# UNITED STATES PATENT AND TRADEMARK OFFICE

APPLICATION NO.	FILING DATE	FIRST NAMED INVENTOR	ATTORNEY DOCKET NO.	CONFIRMATION NO.
10/624,848	07/21/2003	Craig Richard Gerbi	017516-006810US	6559

<b>Office Action Summary</b>	<b>Application No.</b>		<b>Applicant(s)</b>	
	10/624,848		GERBI ET AL.	
	<b>Examiner</b>		<b>Art Unit</b>	
	Natalie Pous		3731

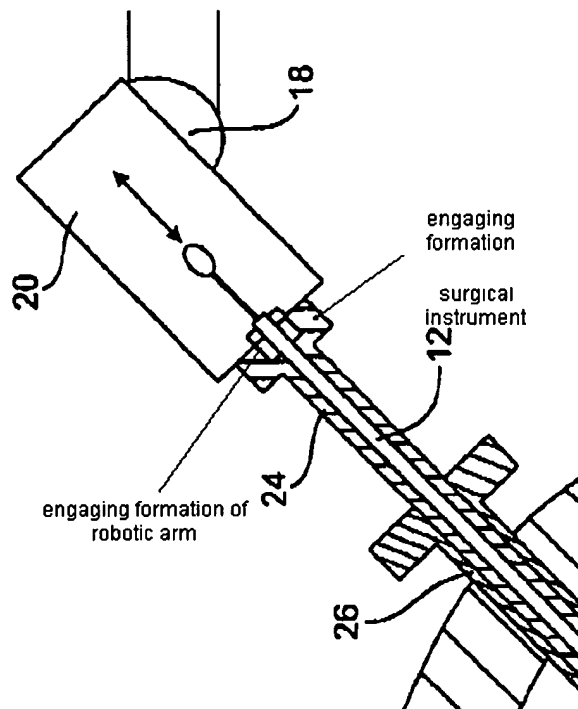
Regarding Claim 18, Wright teaches a tool guide comprising: an elongate body (24) defining opposed ends and a passage extending within the body between opposed ends (fig. 1); and an engaging formation defined within the passage of the body (see fig below), the engaging formation being arranged to hold and provide a stop for a complementary engaging formation on a robotic arm so that a passage defined within the complementary engaging formation is aligned with the passage of the elongate body

and a surgical instrument (12) passing through may be guided to a surgical site (14) in a patient body when the elongate body is inserted through an aperture of the patient body (fig. 1)
